Subject: **Addendum No. 2 to Building 1/36 (Parcel C) Source-Area Groundwater In-Situ Reactive Zone Pilot Study Workplan (Work Plan)**  
**Request to Include Well WCC\_06S as a Contingency Extraction Well**  
Former C-6 Facility, 19503 South Normandie Avenue, Los Angeles, California  
File No. 95-036; SLIC No. 410; Site ID No. 1846000  
Compliance File CI-9310, Order No. R4-2007-0040

Boeing Realty Corporation  
Former C-6 Facility  
Building 1/36 Biorecirculation  
Pilot Study Well Layout

Figure 1

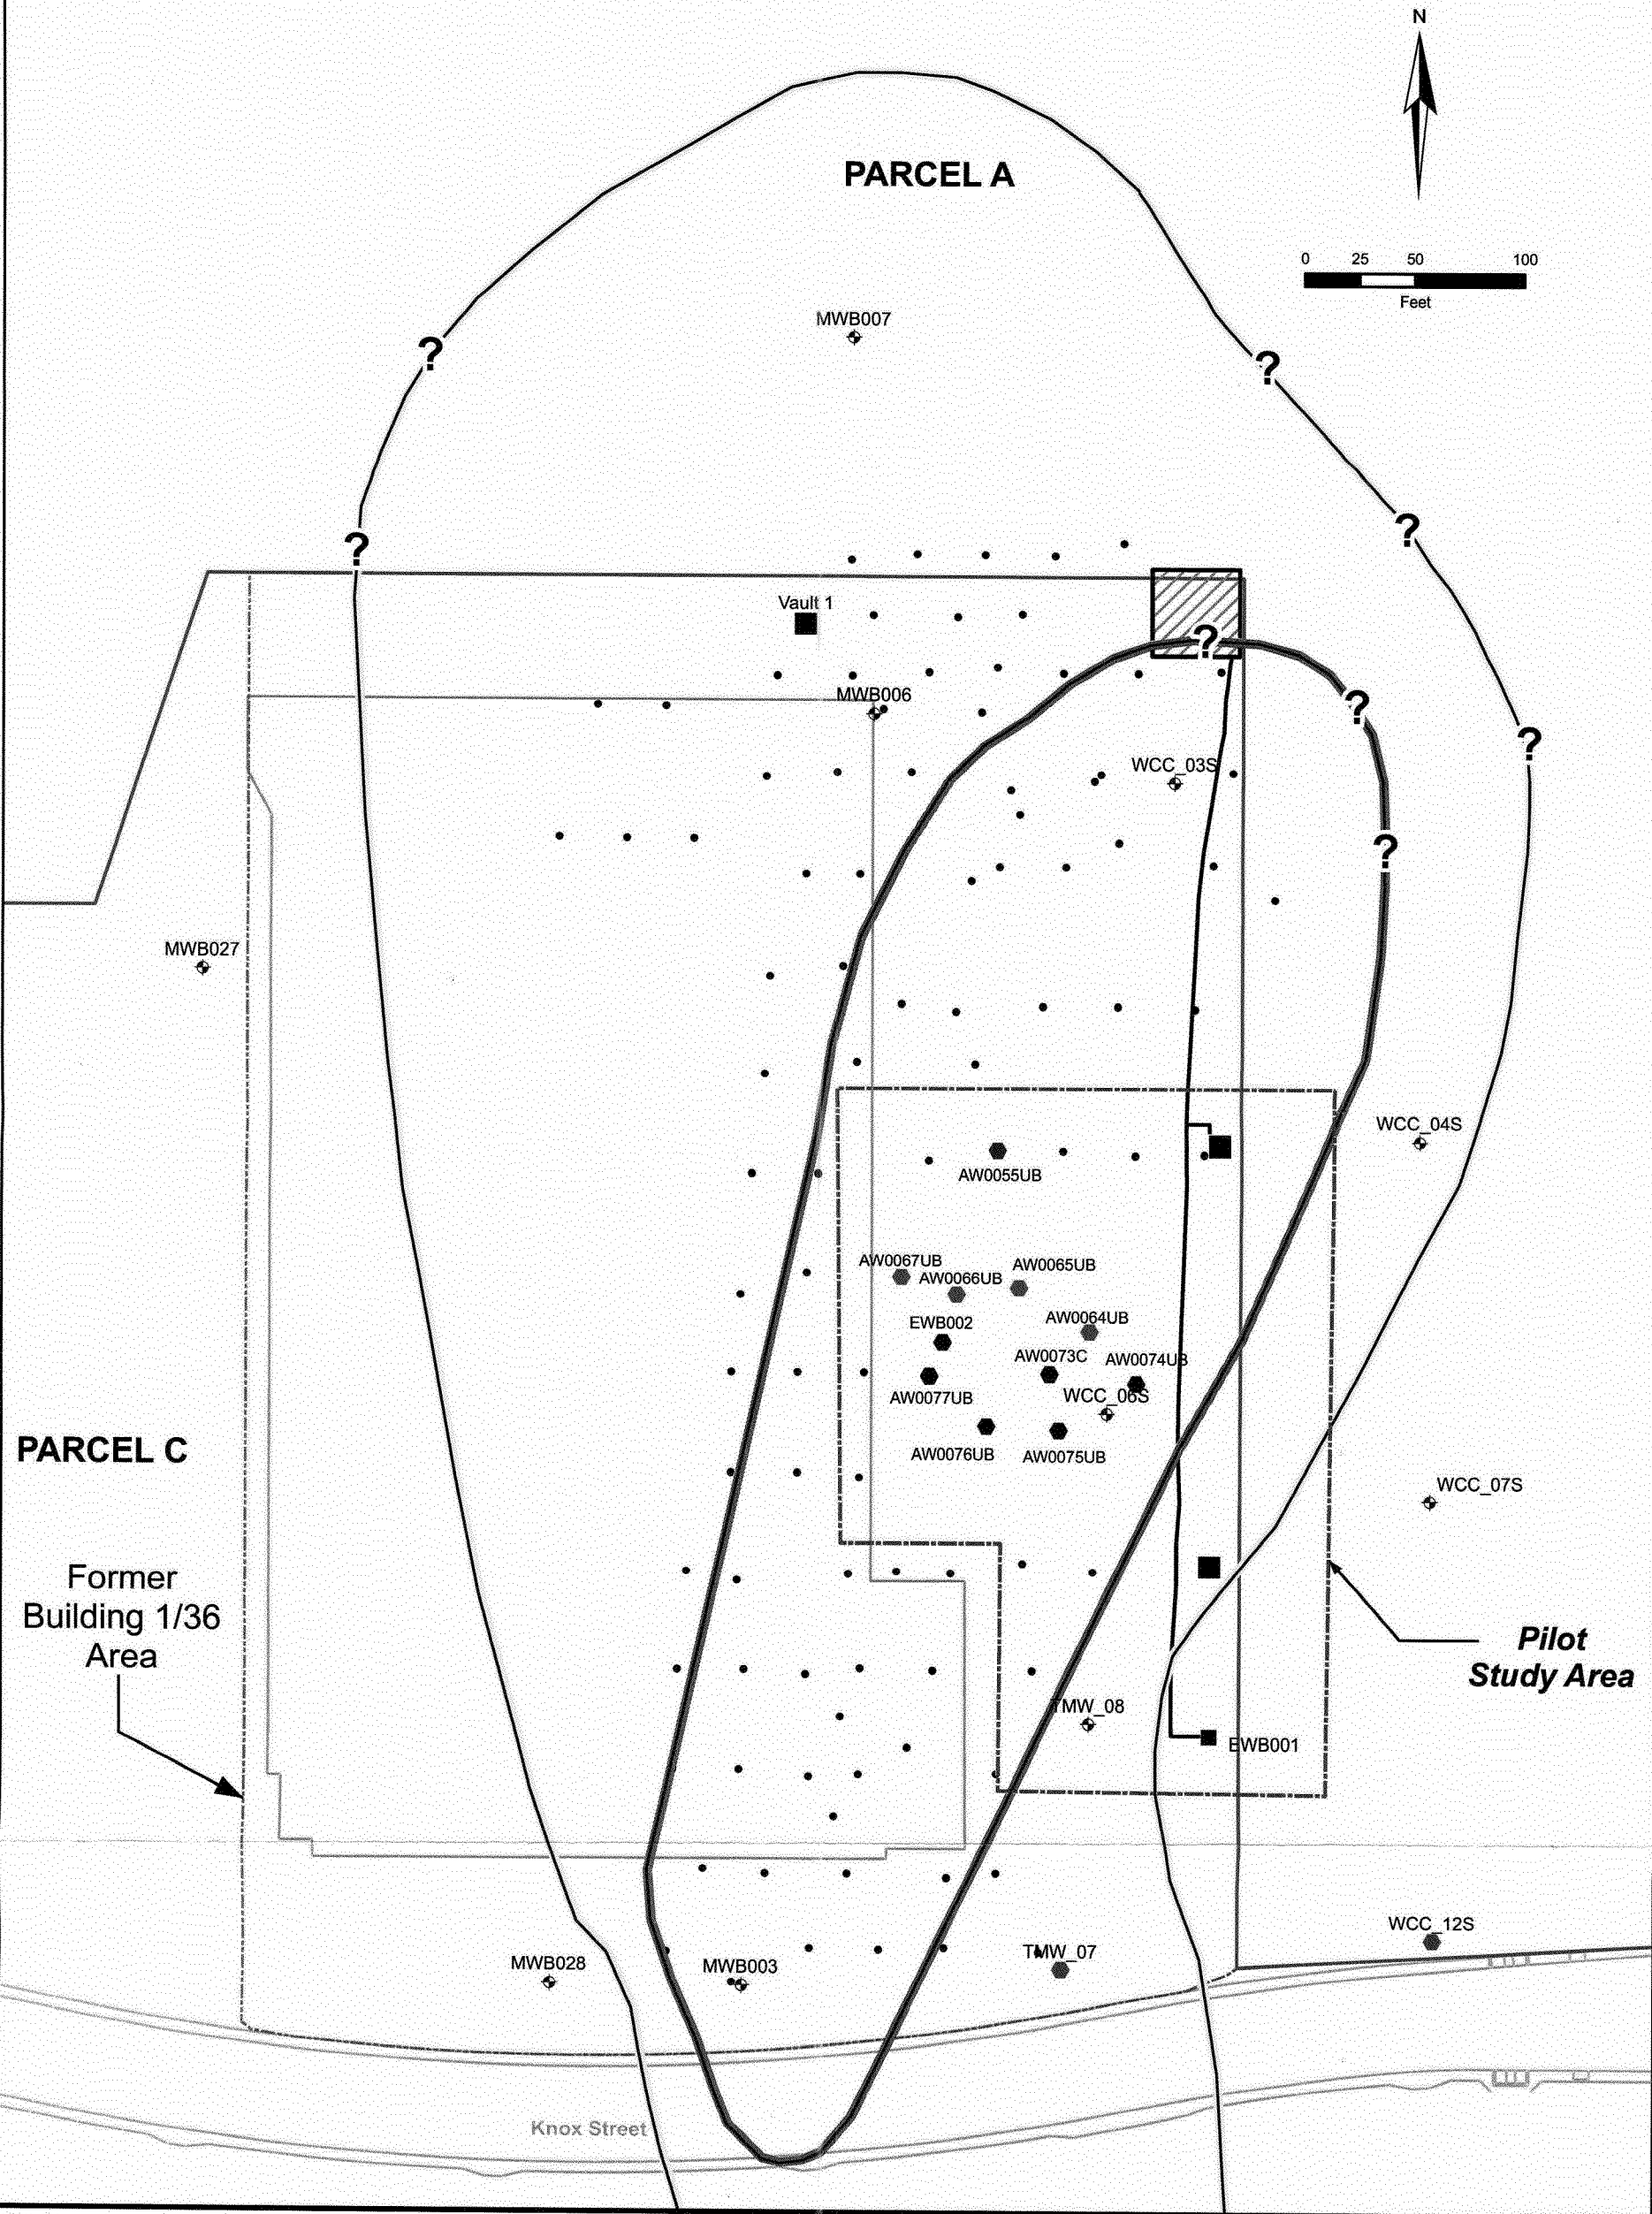
Performance Tests (APTs) at wells EWB001 and WCC\_06S. These additional wells, including WCC\_06S, were selected for testing to provide additional extraction wells besides EWB001, which was the only extraction well included in the Site-Specific WDR Permit. Well WCC\_06S is one of the treatment zone performance monitoring wells (designated as Group B) proposed in the Monitoring and Reporting Program (MRP) under the Site-Specific WDR Permit (See attached Figure 1).

Based on the above-mentioned results, CDM is proposing to add well WCC\_06S as a contingency extraction well for the biorecirculation pilot study. CDM believes that use of WCC\_06S as a contingency extraction well is appropriate for the following reasons:

- Ability to provide supplemental ground water as needed to augment flow from well EWB001 for implementing the pilot study;
- Ability to act as a sole source of groundwater (if necessary) for the pilot study, in the event that well EWB001 does not perform as planned; and
- Optimal location of the well for the pilot study (i.e. downgradient of the injection wells and within the pilot study treatment zone).

CDM hereby requests permission from LARWQCB to allow use of WCC\_06S as a contingency extraction well and proposes the following path forward for the pilot study.

- Start pilot study using well EWB001 at the flowrate of 5 gpm.
- Continue performance monitoring per the Site-Specific WDR Permit.
- Perform evaluation of the monitoring data on a continual basis during system operation to determine if the objectives of the pilot test (i.e. establishing proof-of-concept) are being met.

The results of the evaluation will determine whether or not to bring WCC\_06S online. All extracted water from well WCC\_06S, including the recently generated APT water from this well, will be treated through the pilot system prior to re-injection as required by the Site-Specific WDR Permit. In addition, the current MRP will not be affected by this Addendum, as WCC\_06S will continue to be monitored and sampled per the MRP.
